Addendum #01

Date: May 26, 2023

Project: Longview School District HVAC Replacement and Indoor Air Quality Improvements

DISCOVERY HS
FLOOR PLAN &
ROOF PLAN

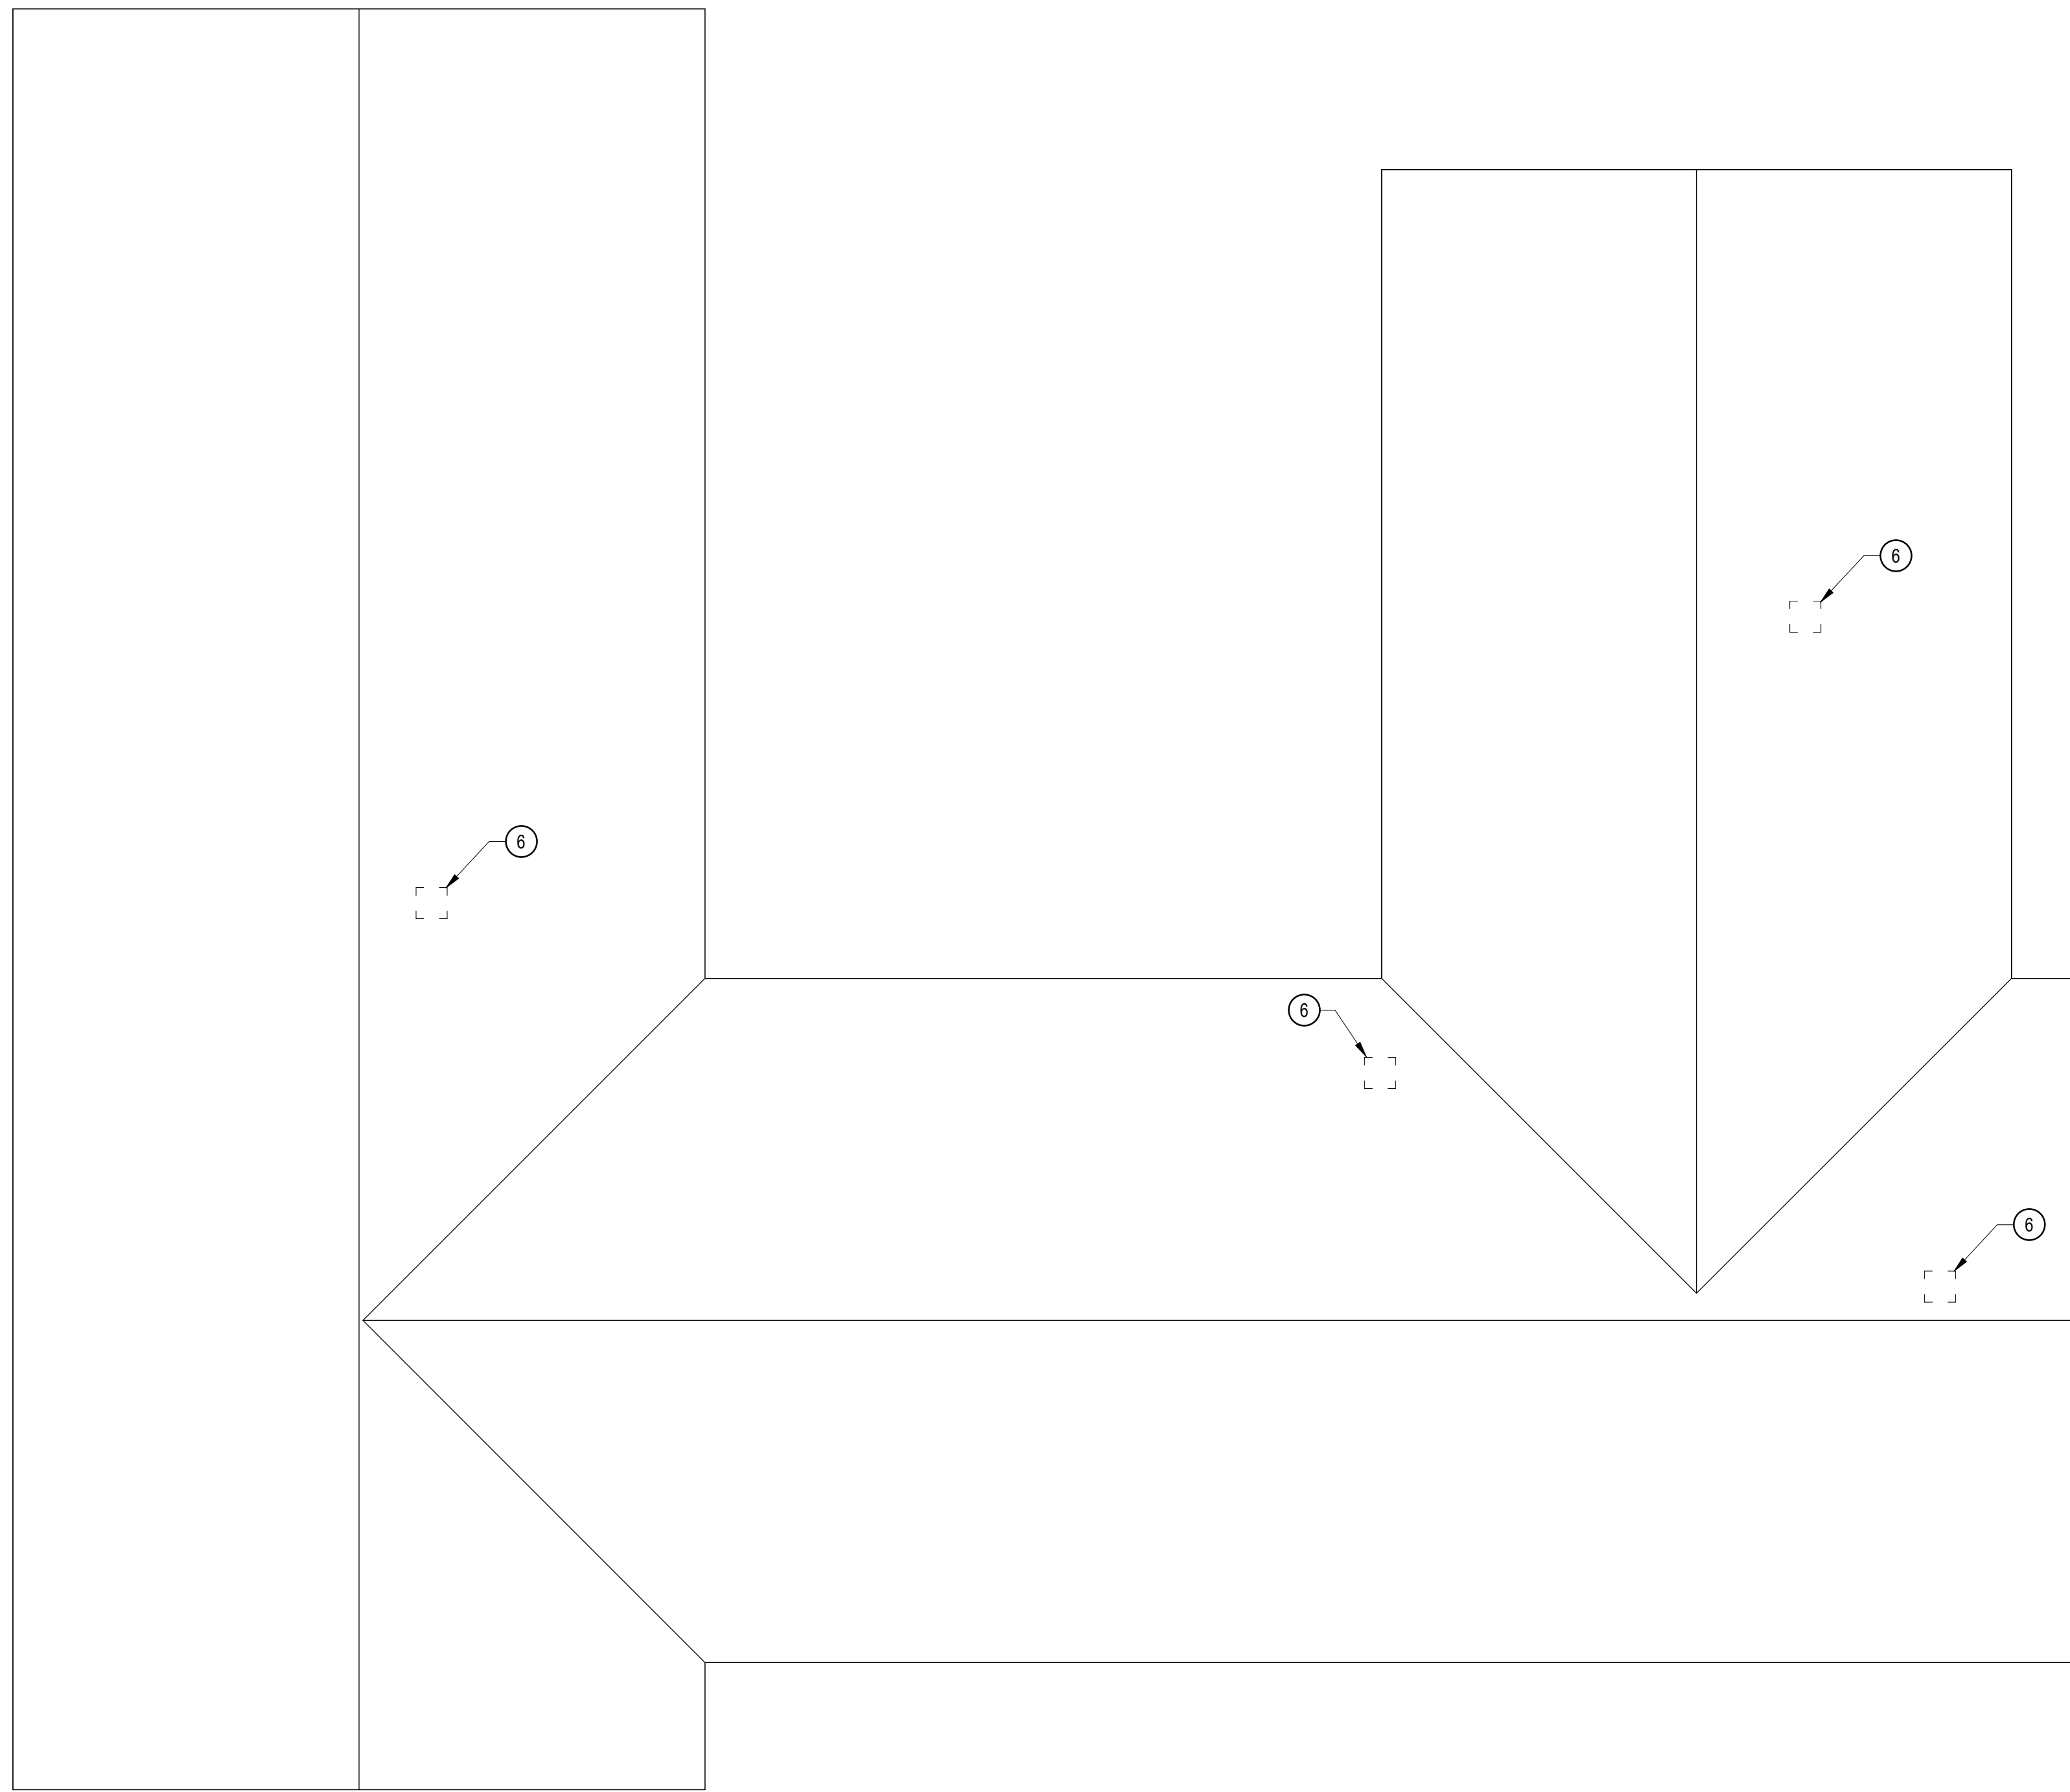
Add. #01 **REVISE:** Sheet A121 to include keynotes 7 and 8 per attached revised sheet A121.

- ① PATCH GWB AS REQUIRED. PAINT.
- ② PATCH GWB AS REQUIRED AT DEMOLISHED MECHANICAL UNIT. PAINT.
- ③ INSTALL RESILIENT FLOORING AS REQUIRED AT DEMOLISHED MECHANICAL UNIT
- ④ NEW 34"H X 54"W ACCESS DOOR ABOVE CEILING
- ⑤ NEW 34"H X 54"W ACCESS DOOR
- ⑥ PATCH ROOFING ASSEMBLY AS REQUIRED AT DEMOLISHED ROOF VENT
- ⑦ REPLACE TRANSPARENT PANEL AT DEMOLISHED AC UNIT
- ⑧ SHEET METAL CAP AT DEMOLISHED DUCT DIFFUSER. PAINT.
